GE Nuclear Energy

Reference: Certificate of Compliance No. 5971, Docket 71-5971

MODEL 200 SHIPPING CASK
CERTIFICATION DWG.
NEXT ASSEM: 129D4756

129D4758

DETAIL B (OPTIONAL)

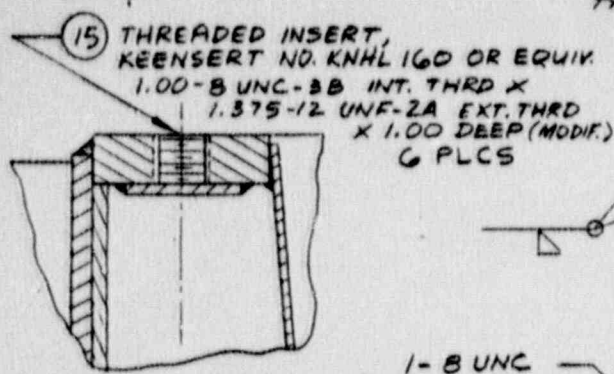
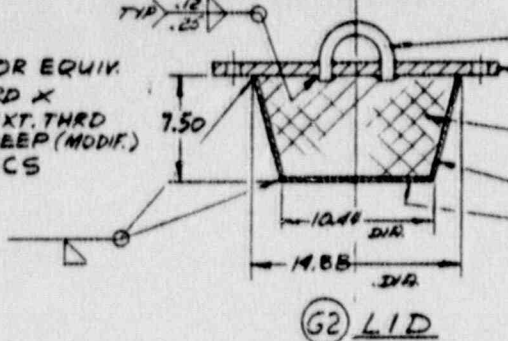
The Model 200 cask body provides six 1"-8 UNC by 1-1/8" deep threaded holes for the installation of the lid. Because of usage the hole threads could be damaged or corroded. To remedy this condition we are proposing the optional use of threaded inserts. Threaded inserts provide strong, permanent metal thread in virtually any material. The proposed insert is of the heavy duty type with an external thread 1-3/8"-12 UNF-2A and an internal thread of 1"-8 UNC to match the present bolts. The bolt hole will be 1" deep. The insert has a positive mechanical lock against rotation during usage. The insert material is 303 stainless steel with a passivated finish. The pull-out strength of the insert external threads is greater than that of the 1"-8 UNC bolts based on their corresponding tensile stress area of 1.315 in.² versus 0.606 in.². Therefore, the inclusion of the threaded insert does not change the working strength of the bolt as currently required by the certificate.

A revised drawing, 129D4758, Revision 3, showing the optional insert is enclosed. This replaces 129D4758, Revision 2.
